Xavier Rixhon's PhD thesis - Answers to jury members

Exploration of uncertainty-aware energy transition pathways -
Reinforcement learning and principal component analysis-based
methods

Figure 1: Storage installed capacities for the REF case

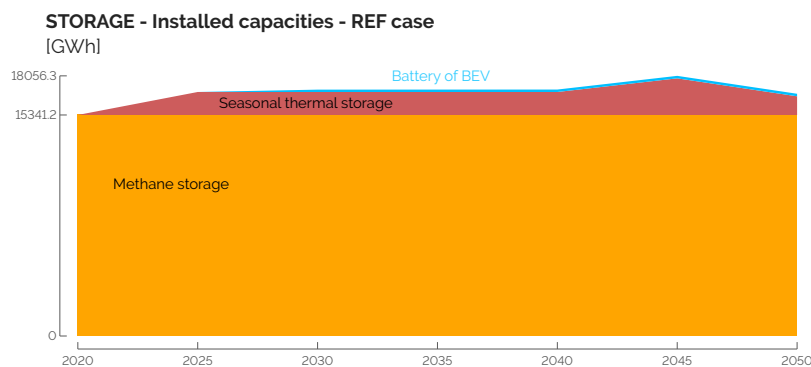
Stefan - Some big topics are missing like storage. Why is storage not more discussed?

As discussed during the private defense, storage is not more discussed in the manuscript for one main reason: the lack of variation through the pathway and under uncertainties. The storage technologies, for the case of Belgium assuming a copper-plate approach, consist in two main technologies: methane storage mostly (about 15 TWh) and, to a smaller extent, seasonal thermal storage (about 3 TWh), with limited variations through the transition (see Figure 1). Analyses under uncertainties have not shown major variations either. Moreover, storage assets are intrinsically linked to the conversion technologies and, consequently, can be seen as by-products of the optimisation results. For these reasons, I have rather focused my analyses on the use of resources and the installation and operation of conversion technologies. Given the discussion during the private defense and these further explanations, I have not brought modification to the manuscript in this regard.

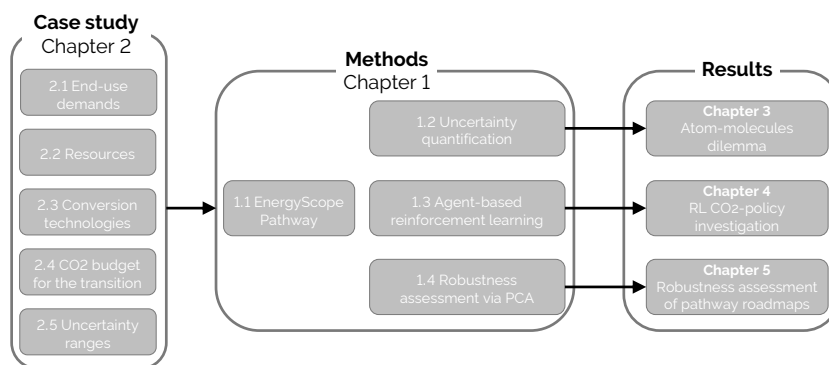
Initially, I wanted to group methodology and results per kind of analysis, i.e., UQ on Pathway (Chapter 3), RL (Chapter 4) and PCA (Chapter 5) but that would have made the RL, and even more PCA, methodology parts come too far in the manuscript. For this reason, I made the choice to group all the methodological approaches together in Chapter 1 and the results in their respective chapters. Given this explanation, I have

Finally, I have added a schematic at the end of the Introduction of the thesis to clarify the structure and highlight that Chapters 4 and 5 can be read after the methodological sections 1.3 and 1.4, respectively (see Figure 2).

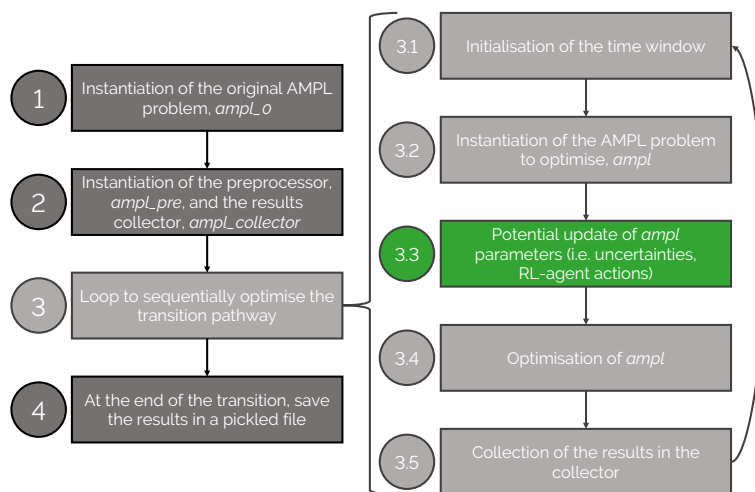
Christophe - Formal description of the problem is missing even if described in the text to make the link between the ideas and the implementation. Add some flow charts to introduce key elements

Besides the mathematical details brought in the description of the optimisation problem, this point is addressed with the structure chart presented in the previous comment as well as the improvement of Figure 1.4 presenting the implementation of the myopic approach as well as the way uncertainties and RL change the values of some parameters (see Figure 3 of the present document).

and extended the caption of Figure 1.4. However, besides highlighting the key step 3.3 where there is an update of parameters value, I have decided to keep the figure as is since, on the one hand, the extension of the caption provides now a better understanding and, on the other hand, the code itself is exactly what is schematically represented on the diagram.

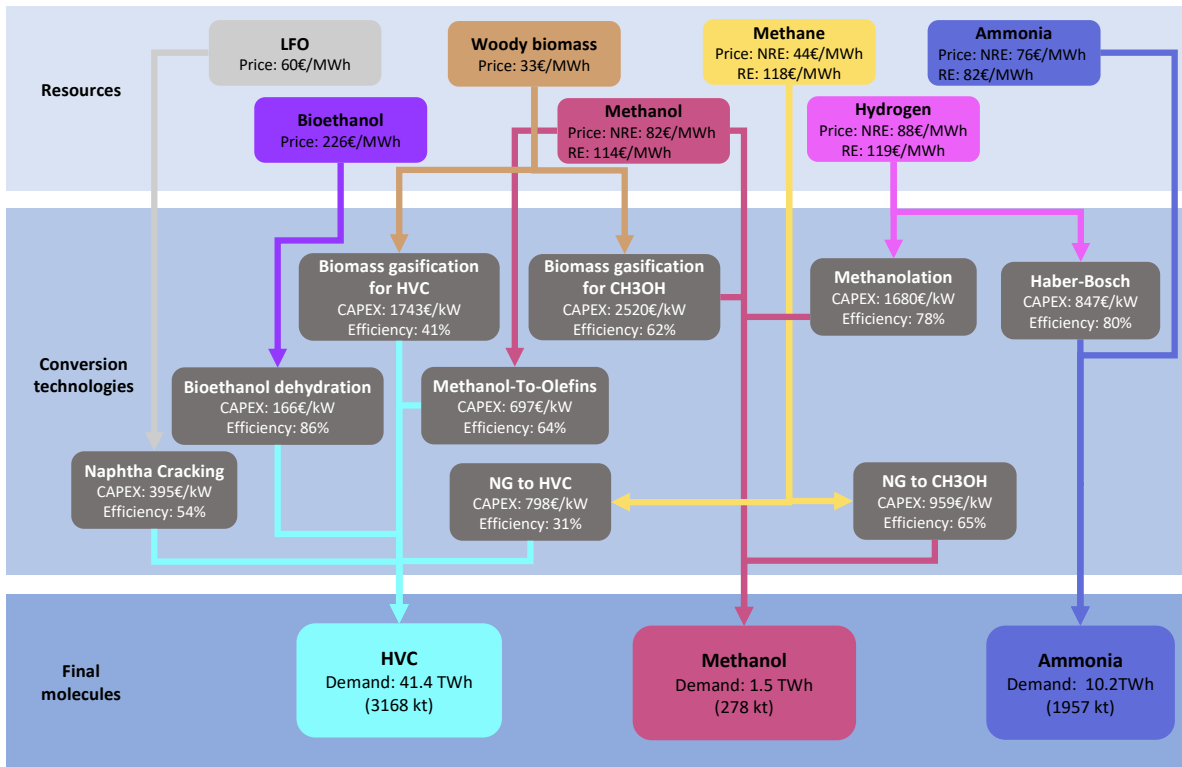
Stefano - Figure 2.5: What is the purpose of the violet line between “biomass gasification” and “methanolation”?

These were actually two different arrows, one pointing from “biomass gasification for CH₃OH” to “Methanol” and the other from “Methanolation” to “Methanol”. To avoid this confusion, the figure has been updated and the origin of these arrows are now on different vertical levels ([see Section 2.3](#)).

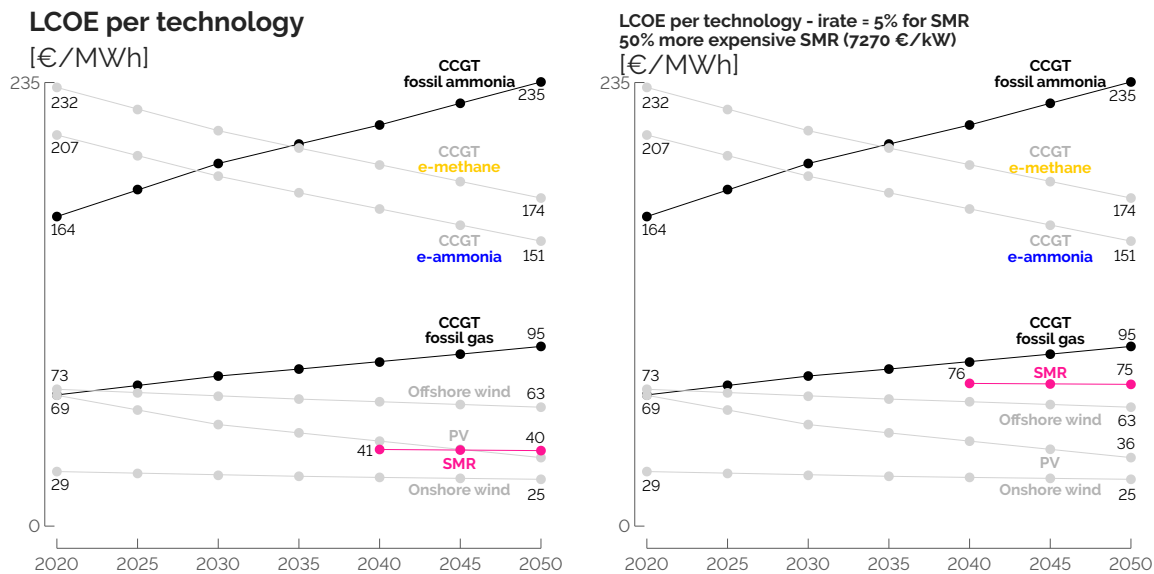
As discussed during the private defense, similarly to EnergyVille [6], we have considered the same CAPEX for SMR as the one considered for conventional nuclear power plants. Where EnergyVille considers a nominal CAPEX of 7500€/kW (like the current large Gen III design of Hinkley Point in the UK), we considered 4850€/kW like the CAPEX of conventional nuclear units in EnergyScope.

On top of the uncertainty applied to the CAPEX of SMR [-40%, 44%] considered in the thesis, I carried out a test on these assumptions by plotting the LCOE of electricity-production units considering different assumptions for SMR (see Figure 4.3). Even considering 50% more expensive SMR subject to a higher discount rate (5% versus 1.5% for the other technologies), we notice that SMR keeps on being more cost-competitive than other flexible production units, like e-ammonia CCGTs, that are substituted by SMR when the latter can be installed (see Chapter 3). In other words, it means that the optimistic values assumed for SMR in the thesis lead to a cheaper whole-energy system but do not affect its design, i.e., the installed technologies. Consequently, no further modification has been brought to the thesis regarding this comment.

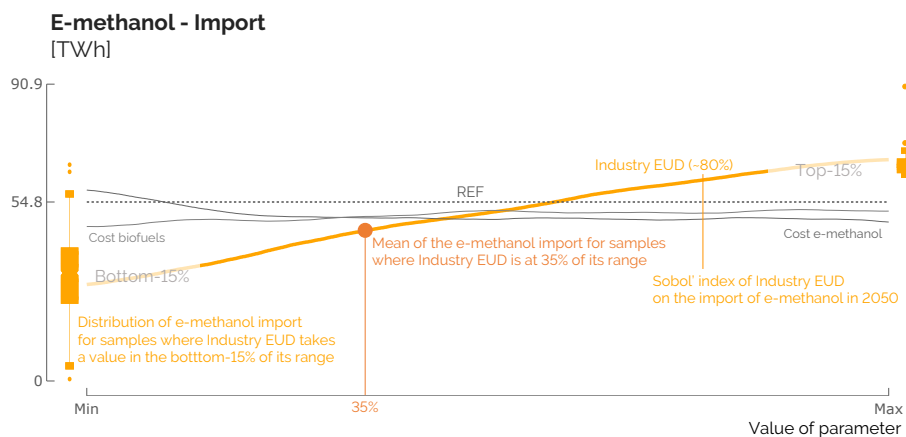
Stefano - p. 74 - Figure 3.8: this graphs looks potentially interesting but it is not sufficiently well explained.

The objective of this set of figures is to point out the key parameters that drive the variation of some outputs of interest. Taking the case of Figure 3.8, we focus on the import of e-methanol in 2050. On the x-axis, we represent the value taken by the uncertain parameters in the different samples. As the range is not the same for all the parameters, we have limited this axis from “Min” to “Max”. The y-axis represents the feature of interest. The drawn lines represent average trend lines between the output of interest and one specific parameter. For the case of Industry EUD, for samples of the GSA where this uncertain parameter is at 35% of its range, the mean value of methanol imported in 2050 is roughly 50 TWh. The distributions present on the extreme left and right of the graphs correspond to the distributions of the output of interest for the samples of the GSA where the considered parameter takes a value in the bottom (left) or top (right) 15% of its range.

To improve the readability of this figure, I have updated the text zones to specify that these lines and distributions represent results of some specific samples of the GSA. Additionally, I have added a text zone to remind that the value between brackets is the Sobol’ index of the considered parameter regarding this specific output of interest, and added this information in the caption of the figure:

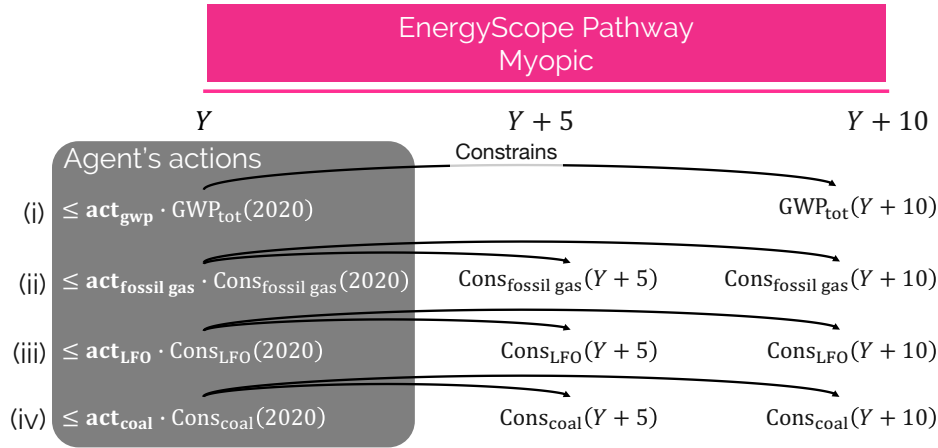
Stefano - Overall, I suggest adding a diagram to Chapter 4, detailing what are the actions available to the decision-maker.

Complementary to the text in the core of the manuscript, I have added a diagram to detail the agent's actions and how they impact the model: taken at the beginning of the time window to optimise (year Y), the four actions impact (i) the emissions of the system at the end of the time window (year $Y + 10$) and, (ii-iv) the consumption of fossil gas, LFO and coal at years $Y + 5$ and $Y + 10$.

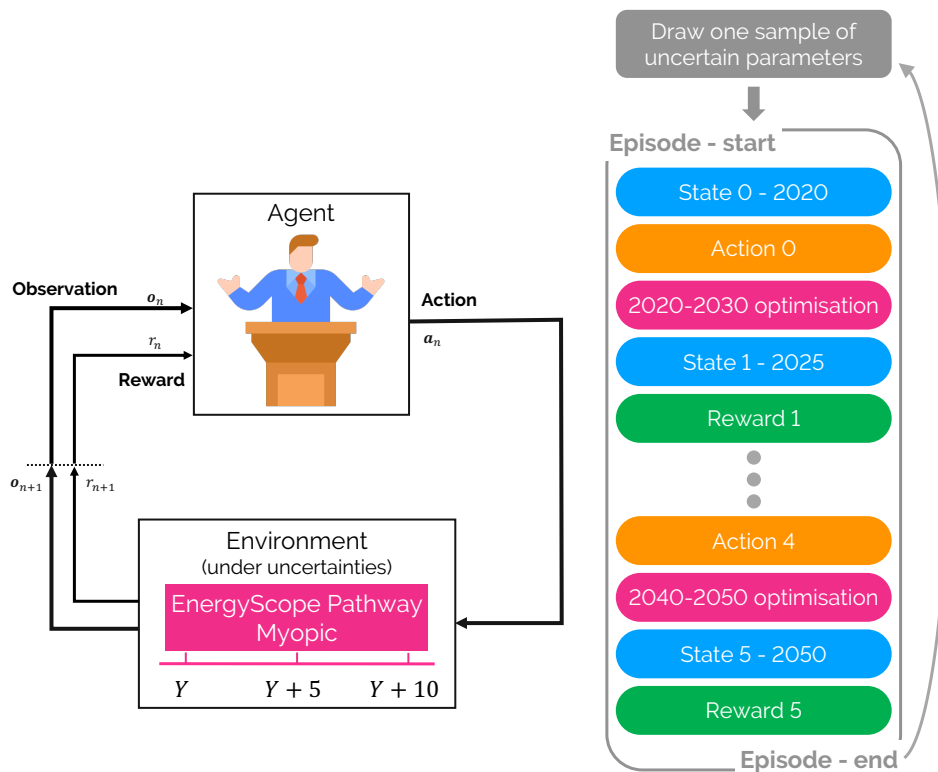
Stefano - Explain more in details the different steps in the RL approach.

Both, agent's actions and exogenous uncertainties, change the value of some parameters of EnergyScope Pathway. However, where the sample of uncertainties is drawn once and for all at the beginning of the episode as explained in Section 1.2.1, the agent's actions are taken at the beginning of each 10-year time window. This is now clarified [at the beginning of Section 1.3.2 and the updated version of Figure 1.7, and its caption](#) (see Figure 7 in the present document):

Before starting an episode, a sample of uncertain parameters is drawn and affects the environment, EnergyScope Pathway, according to the methodology detailed in Section 1.2.1.

Besides the general concepts/fundamentals detailed in Section 1.3.1, the application of the RL approach on the myopic optimisation of the energy transition of a whole-energy system is detailed in Section 1.3.2. Now, Figure 1.7 has been updated to clarify the difference between the uncertainty of parameters and the agent's actions as well as the interactions between the RL code (action, state, reward) and EnergyScope Pathway (optimisation of the concerned 10-year time window). I have also added a diagram to explain the impact that the agent's actions have on some parameters of the model.

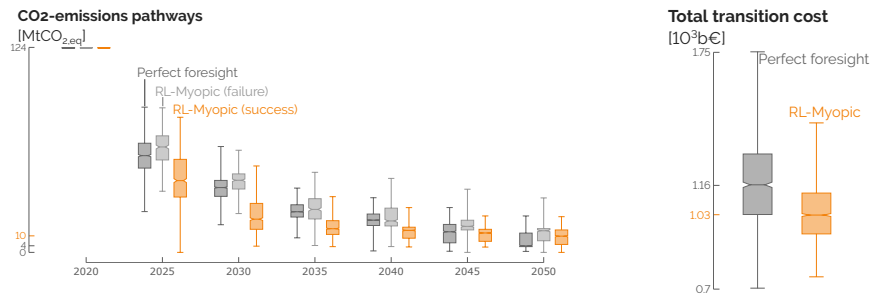
This was observed on the annual system cost which is not the objective function of the Pathway model. It is more relevant to look at the total transition cost which is, logically, lower for the PF approach compared to myopic when facing the same sample of uncertain parameters. To clarify this aspect, I have removed the paragraph (and the graph) about the comparison of the annual system cost and added instead a paragraph (and a graph) about the comparison of the total transition cost [in Section 4.3](#):

Looking at the total transition cost, the combination of the agent's actions and favourable economic conditions (see Section 4.2.2) make the myopic transitions cheaper, on average, than the PF cases (see right side of Figure 8). This is also due to the fact that the perfect foresight approach always finds a solution even in worst conditions such as high cost of purchasing resources and high EUD. This explains the wider variability of the results too. However, with the same sample of uncertain parameters, given the assumed full knowledge over the whole time horizon, PF naturally results in a cheaper transition than its myopic equivalent.
